Landscape Referral Response

Application Number:	DA2023/0951
Date:	27/03/2024
Proposed Development:	Alterations and additions to the Royal Motor Club Broken Bay
Responsible Officer:	Adam Croft
Land to be developed (Address):	Lot 5 DP 4689 , 46 Prince Alfred Parade NEWPORT NSW 2106 Lot 6 DP 110670 , 46 Prince Alfred Parade NEWPORT NSW 2106 Lot 262 DP 752046 , 46 Prince Alfred Parade NEWPORT NSW 2106 Lot 329 DP 824292 , 46 Prince Alfred Parade NEWPORT NSW 2106

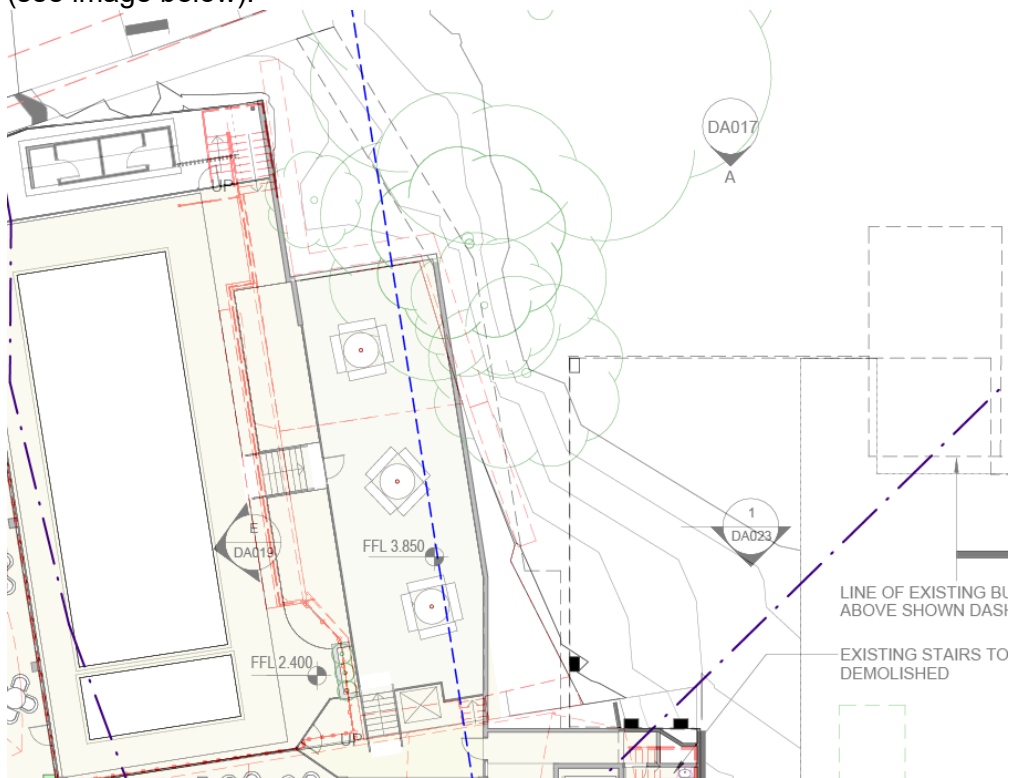
Landscape Referral does not support the removal of trees 2 and 4. An overlay of the drawings Demolition - First Floor Plan (DA004) and Proposed Partial Site - Ground Floor Plan (DA008) shows that the proposed upper pool terrace area is mainly contained to the existing upper pool terrace area (see image below).

Any new retaining structures shall be wholly contained within the existing footprint of the upper pool terrace area, so as not to disturb existing trees 1, 2, and 4. The proposed service and fire egress pathway is labelled 'indicative location' on the plans. This pathway shall be located and designed in collaboration with the Arborist to ensure trees 1, 2, and 4 can be retained. The Arborist shall provide updated commentary on any design changes and to confirm the retention of trees 2 and 4.
